Response to comments from Anonymous Referee #3 on manuscript egusphere2022-565: "Development of an automated pump efficiency measuring system for ozonesonde utilizing the airbag type flowmeter"

Figure 15: (Upper) Pump correction factors at 10 hPa measured during 2009 to 2022, sorted by ozone sensor serial number.

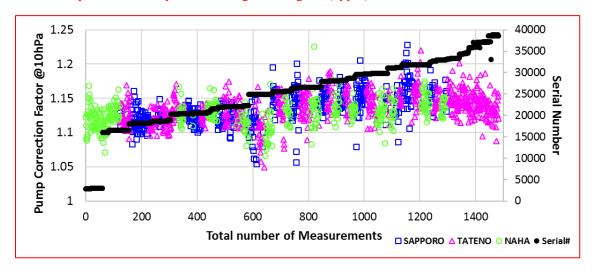
Figure 15 (upper) appears to be wrongly labelled on the x-axis.

We will replace the x-axis label with "Total number of measurements", add "Serial number" to the second vertical axis, and replace the description of the figure in Fig. 15 (upper) as follows.

Figure 17: (Upper) Estimation of impact on total ozone integrated values when using average pump efficiency correction table. (Lower) The impact on total ozone integrated values for each serial number lot, with the error bars indicating the standard deviation.

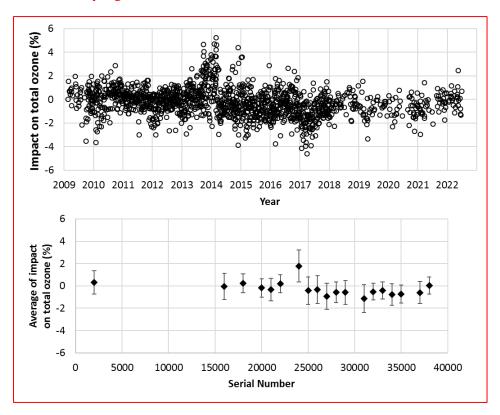
Lines 403-406 (and Figure 17 caption): I am confused by this description. Should you not simply calculate the difference, for each sounding, in the total ozone found using your measured pump corrections to that using the average pump correction curve (either CMDL or your average before serial #24000 – or after serial #24000)?

We recalculated for Figure 17.

We will replace lines 403-407 with

"Fig. 17 shows the impact for the total ozone integrated values if the table values of the pump correction factors measured by JMA for the ozone sensor serial number before 24000 was used instead of using the measured individual pump efficiency correction values. We calculated the impact using the average ozone partial pressure of JMA from 1994 to 2008, which is a typical mid-latitude profile. The ozone partial pressure using the table values of the pump efficiency correction is obtained by dividing the average partial pressure value by the measured pump correction factor and then multiplying that value by the table value. Each of these ozone partial pressure values at each pressure levels (the ground level pressure, 500, 200, 100, 50, 30, 20, 10, 7, 5 hPa) was integrated to determine the total ozone integrated value, and the relative difference was determined for each of the pump efficiency measurements during 2009 - 2022."

We will modify Figure 17 as follows.
